SAN JOSE SHELTER FOR THE HOMELESS

COST FREE CLARIFICATION

CLARIFICATION no: 57
Date: 5/1/89

REGARDING DINING HALL ROOF SHEATHING

4x4 BLOCKING AT
ROOF PEAK

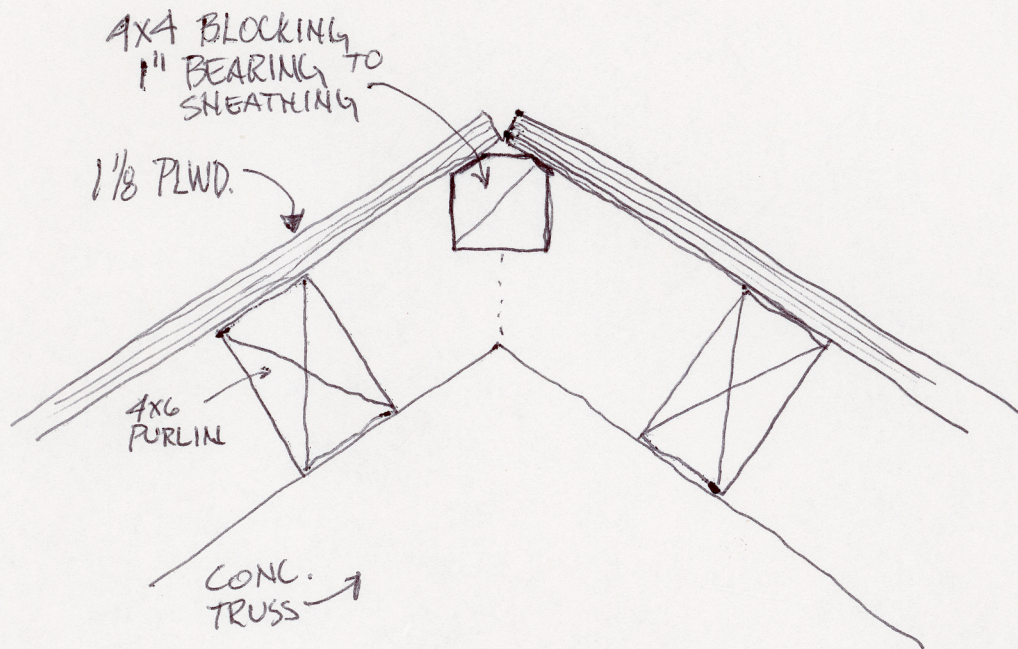
4X4 BLOCKING shall be installed at roof peak according to the attached sketch.
